January 30, 2019
ADDENDUM NO. 1

Northern Kentucky University

**Commonwealth Hall Renovations
NKU-16-19**

DATE	1/30/19
COMM NO	2018066.01
ASK 01

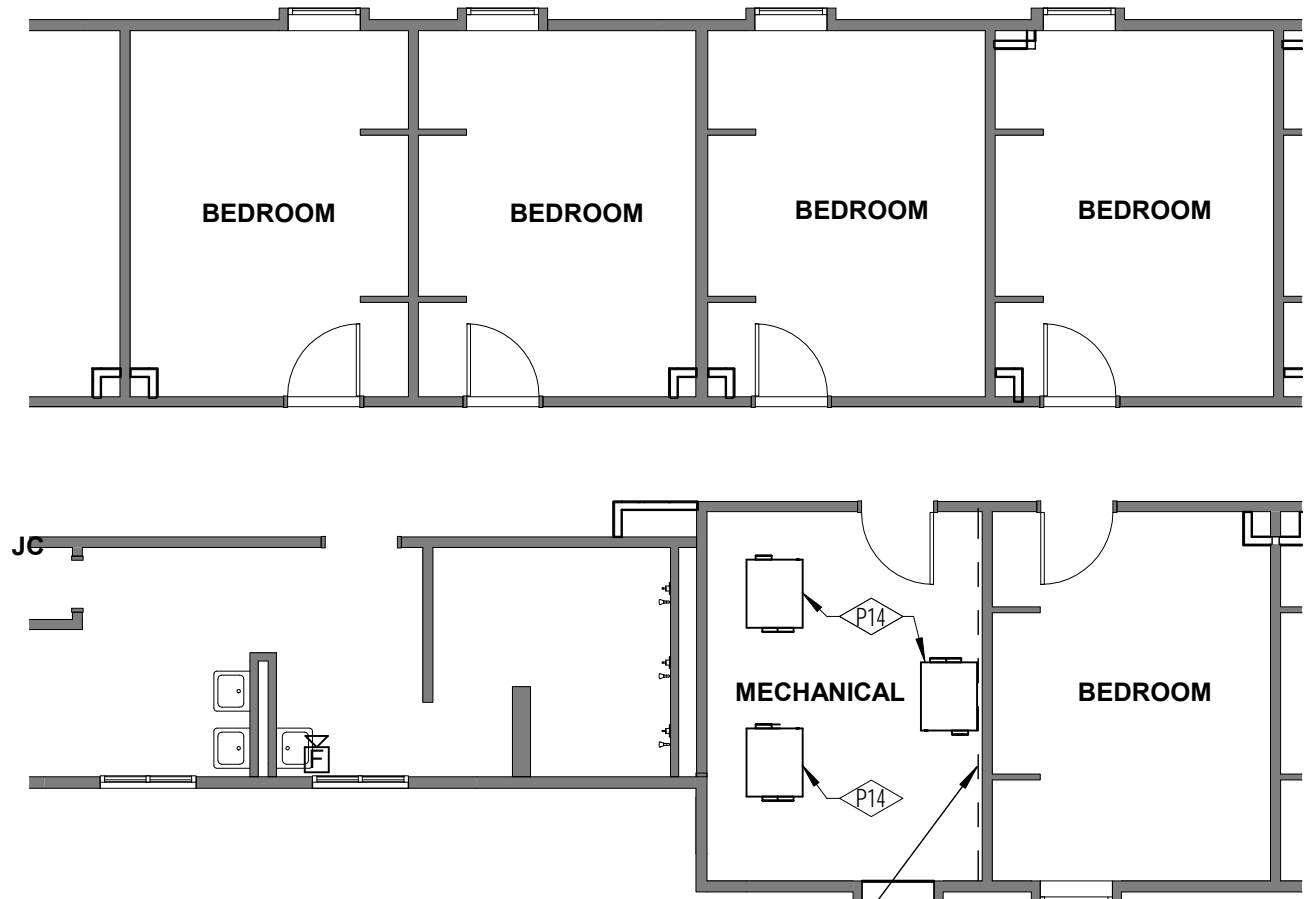
Item #2: Mechanical Room sound control

Install new gyp board, hat channels and acoustical sealant as shown in attached sketch ASK-01 in all three third floor mechanical rooms.

INSTALL ONE LAYER OF 5/8" GYP BD ON 7/8" HAT CHANNELS AT 16" O.C. THIS WALL, FLOOR TO CEILING, WALL TO WALL. SEAL ALL PERIMETER EDGES OF NEW GYP. BD LAYER WITH ACOUSTICAL SEALANT.

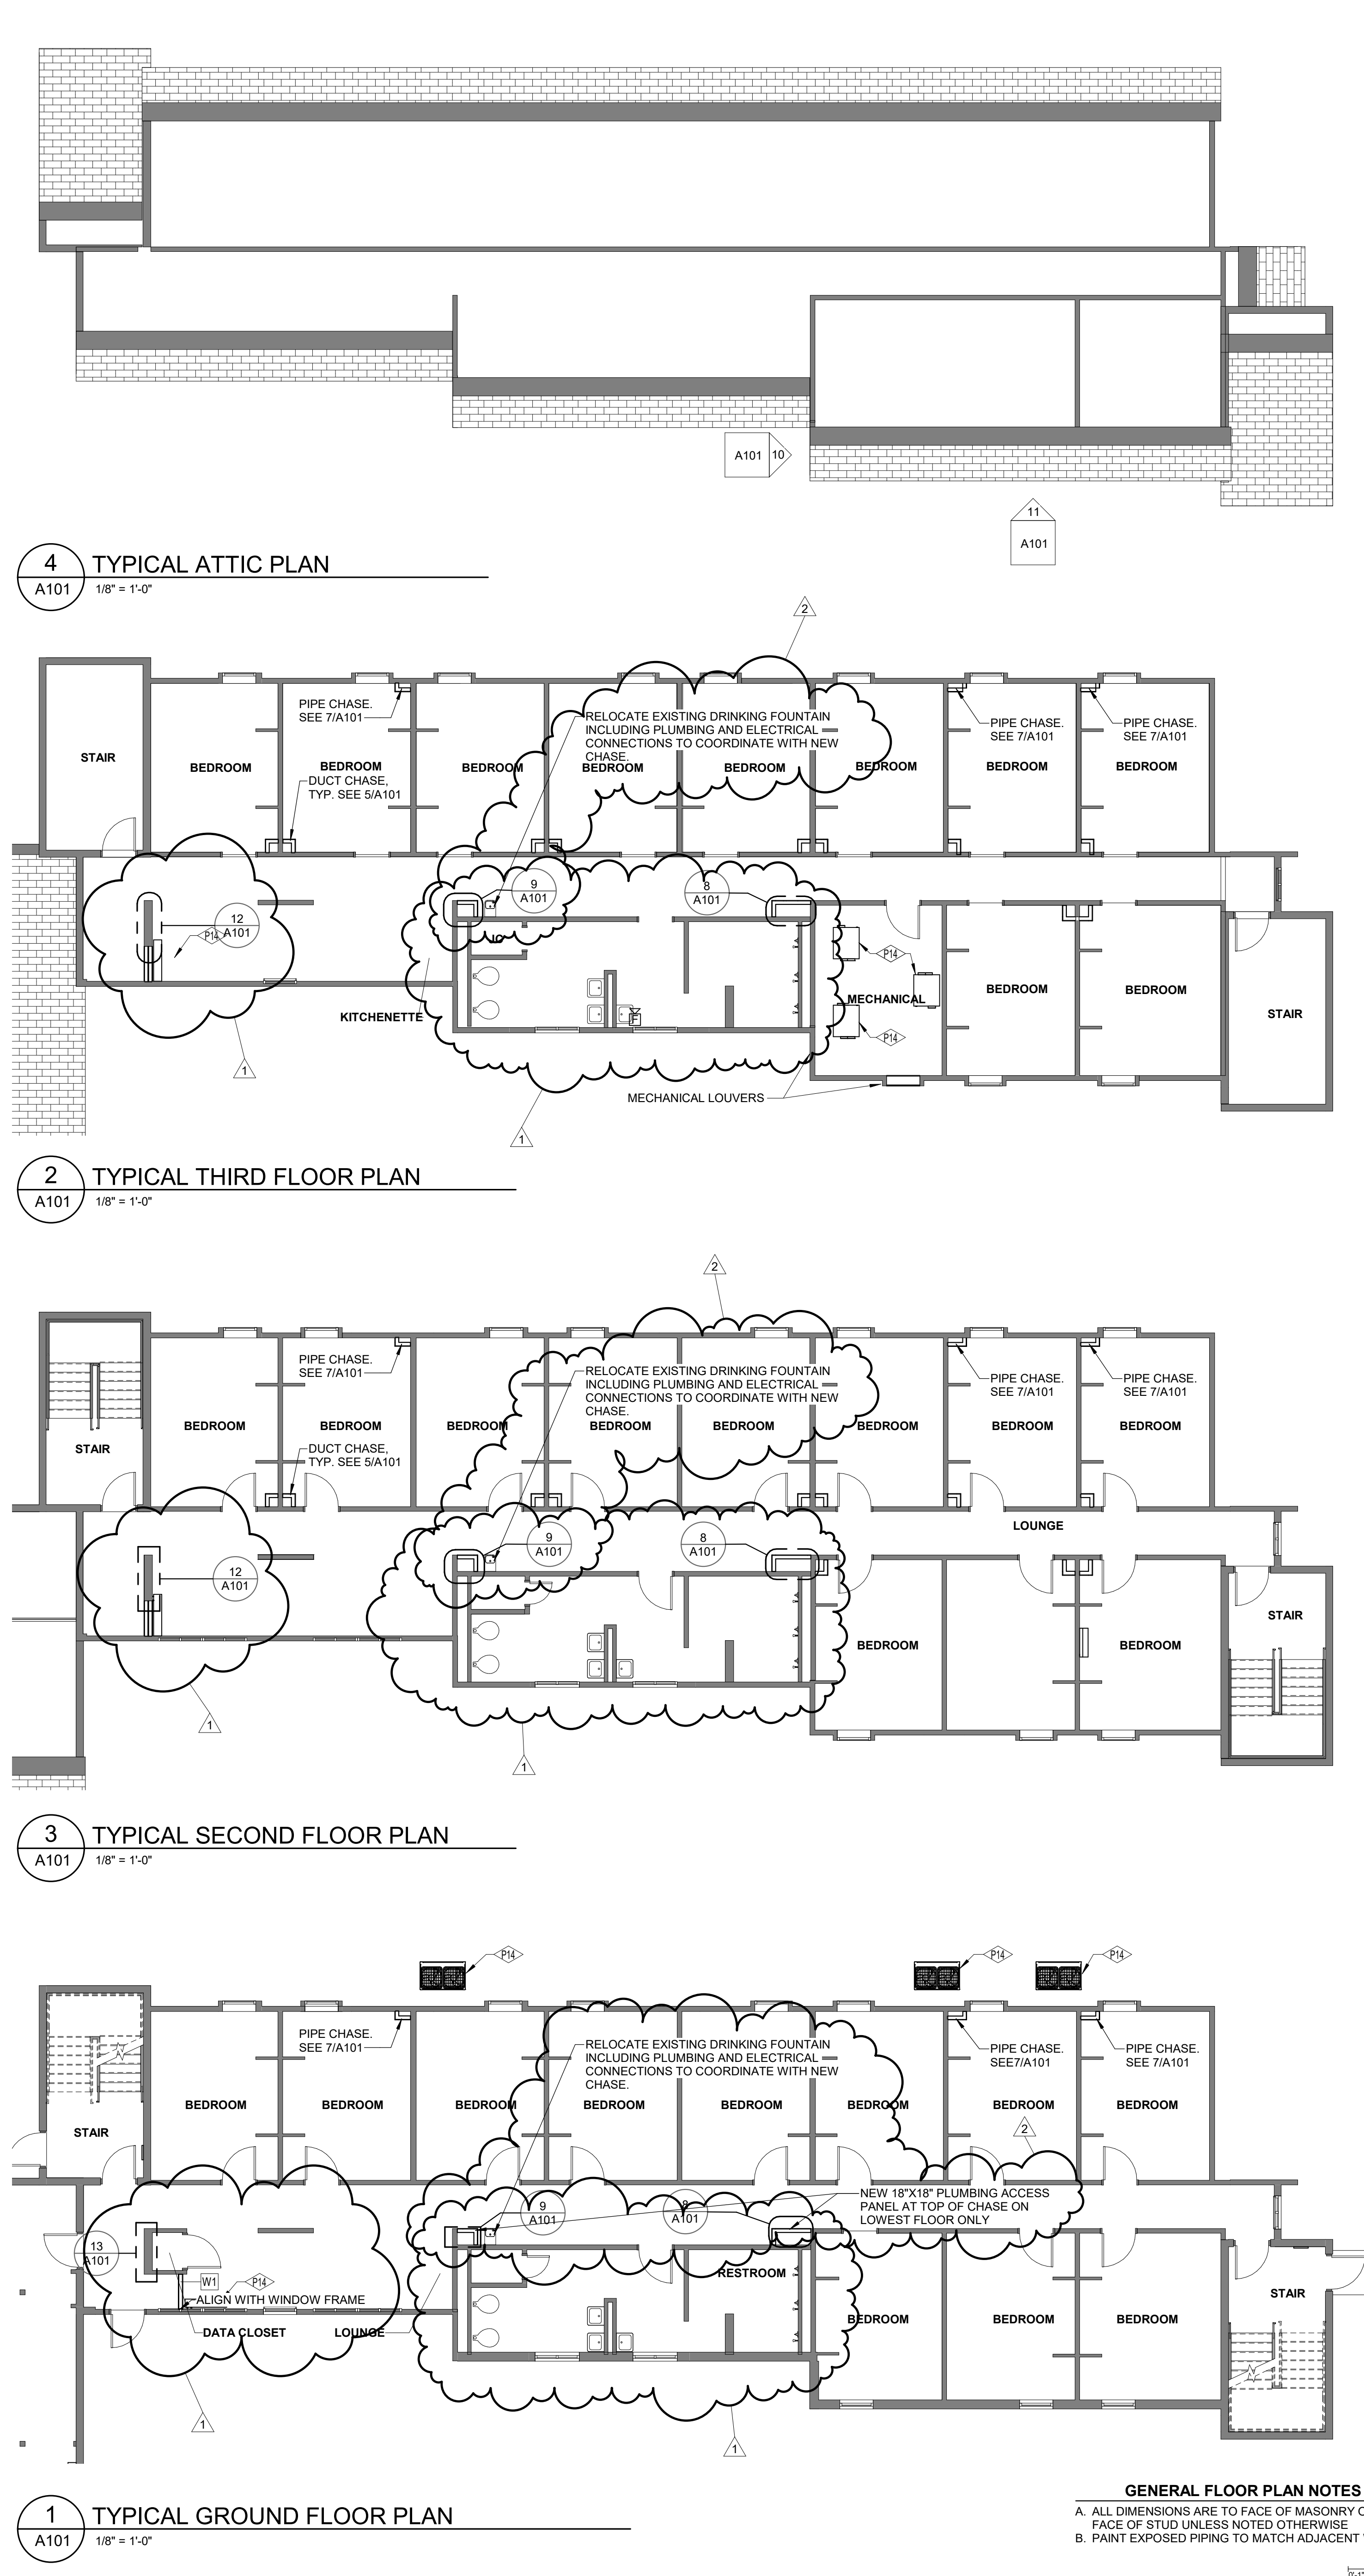
Item #3: Sheet A401

See changes made on this sheet:

- The chase shown in detail 9/A101 has been enlarged
- A note has been added to the two new chases near the restrooms on the lowest level to add an 18"x18" plumbing access panel at each.
- A note has been added on all three typical floor plans to relocate the existing electric watercooler/drinking fountain and associated plumbing and electrical connections to coordinate with new chase.

INTERIOR FINISH PLANS	
DATE	10/19/18
COMM NO.	2018066.01
A601

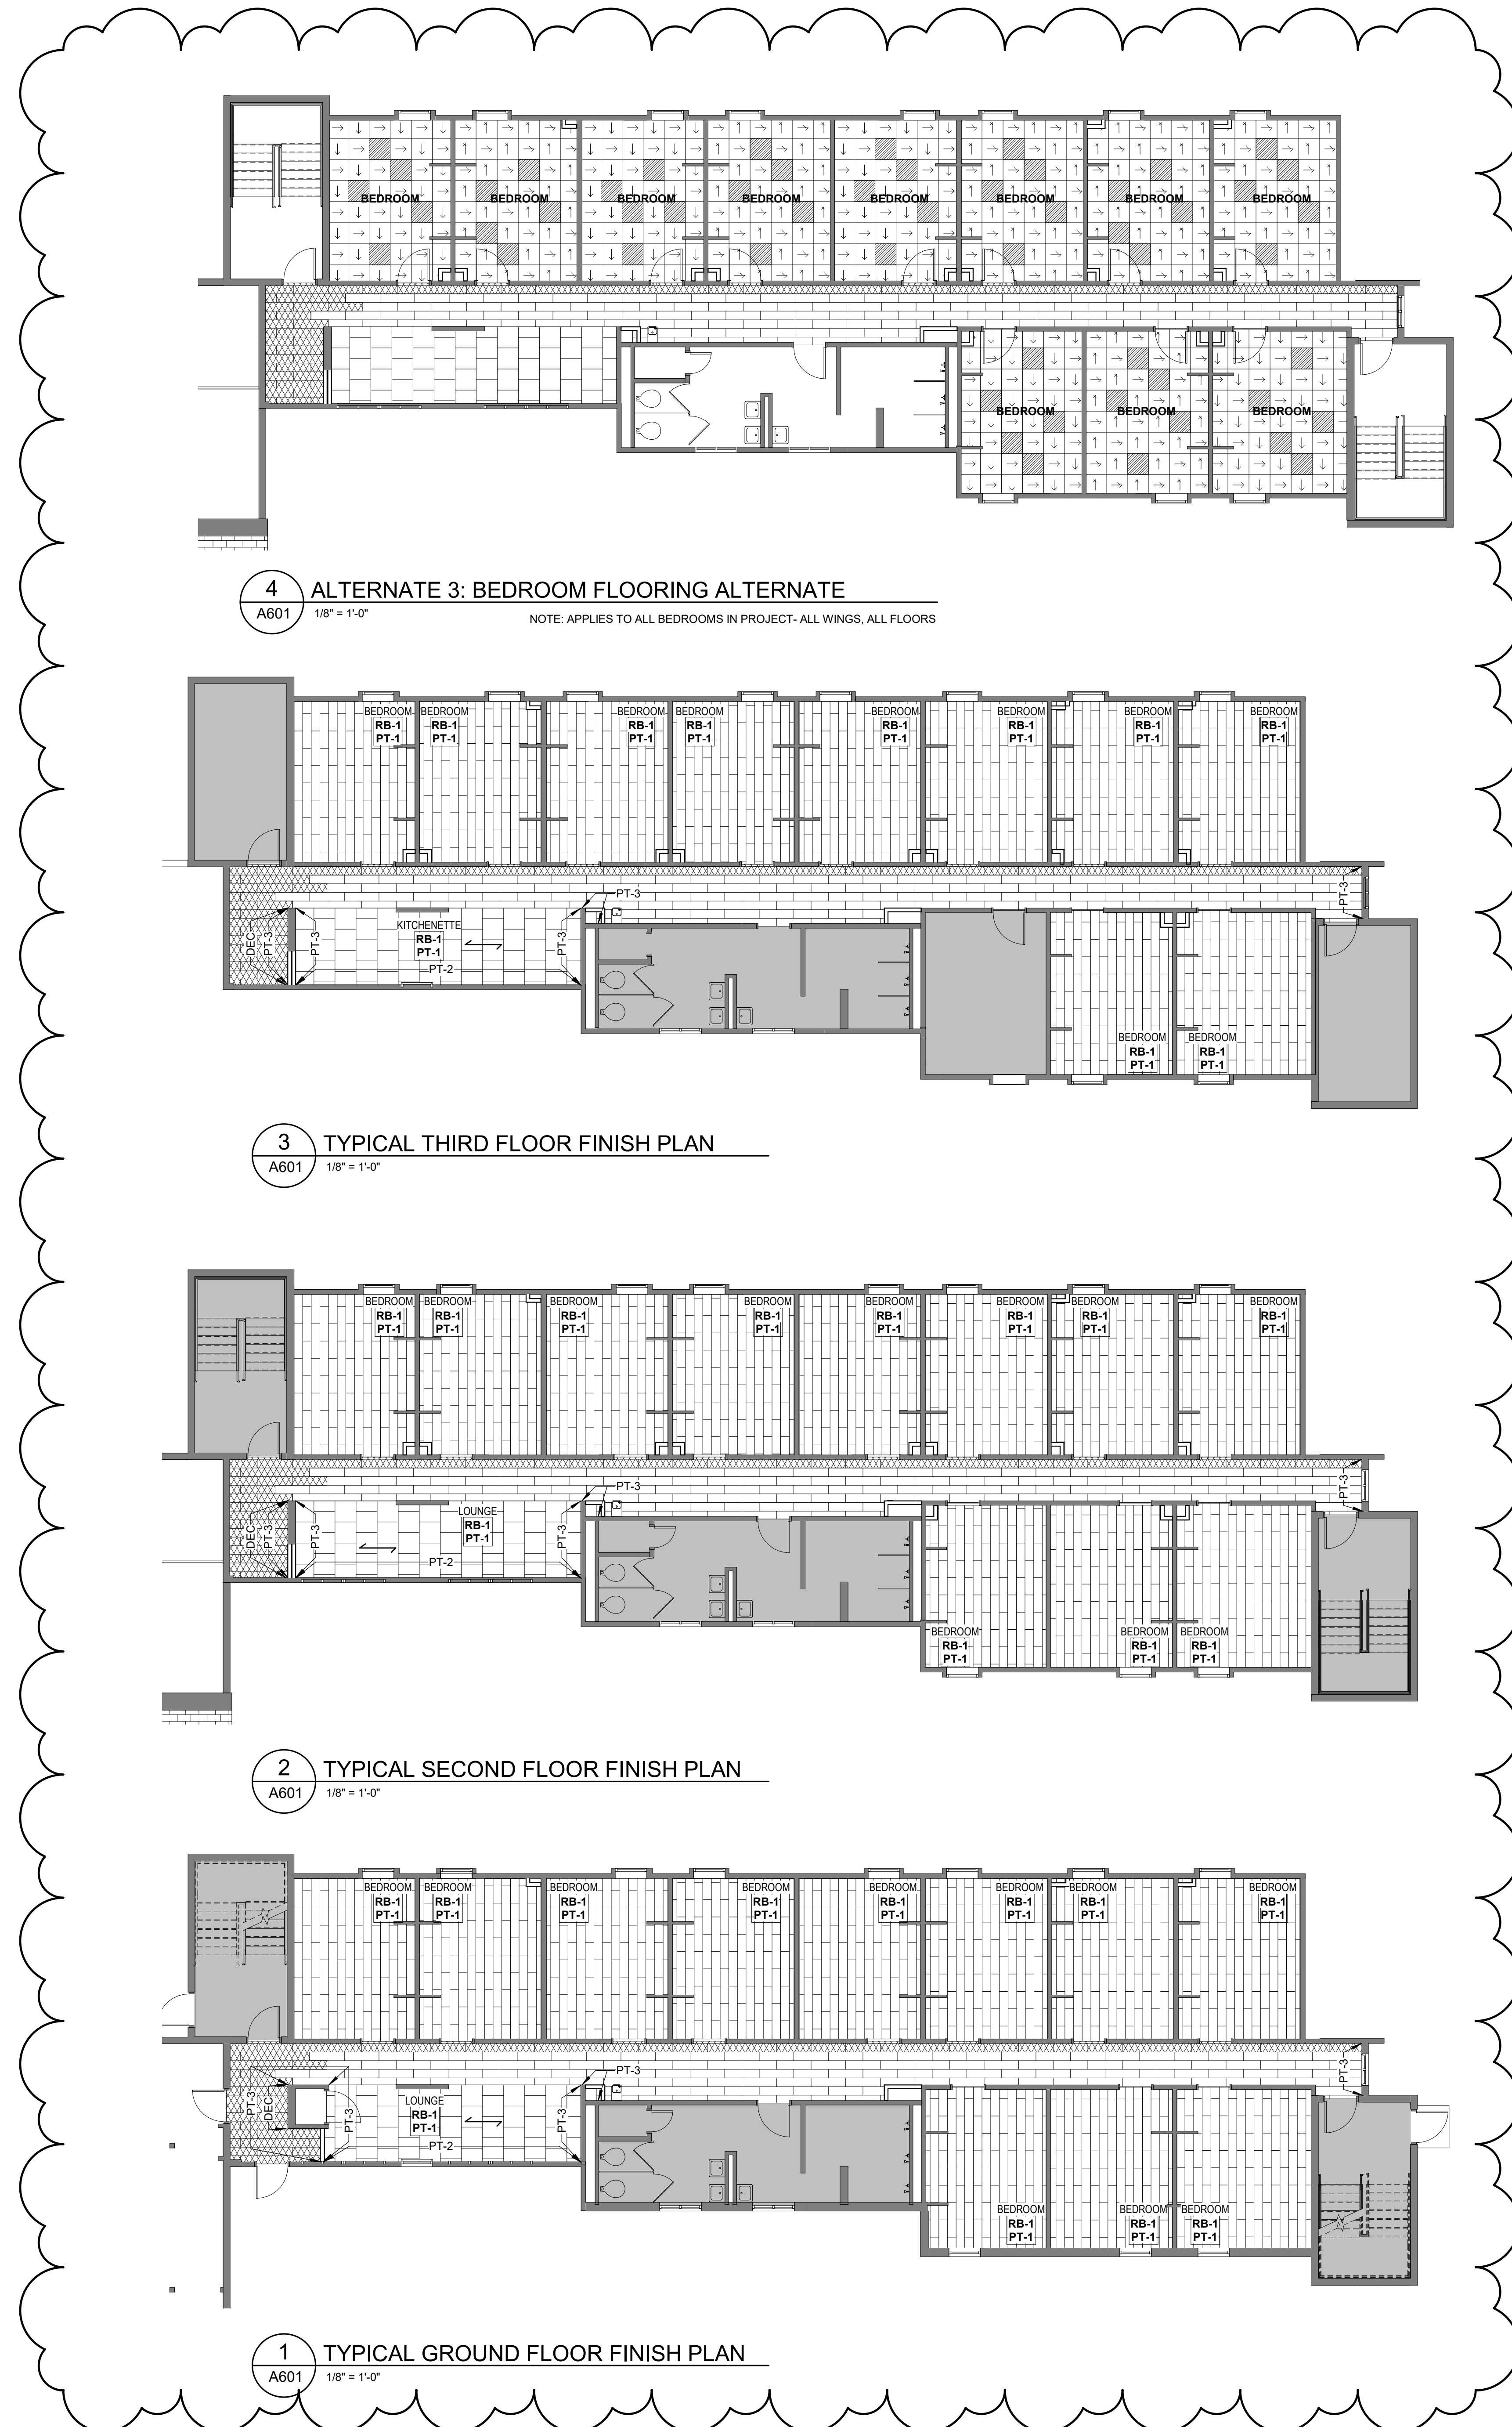
Item #4: Sheet A601

See revised sheet A601.

- This revises flooring shown in bedrooms to LVT-1. This change impacts Alternate #2.
- Drawing 4/A601 has been added to show the condition of new Alternate #3 which utilizes Kinetex (CPT-2 and CPT-3) in the bedrooms in lieu of LVT-1 as Alternate #3.
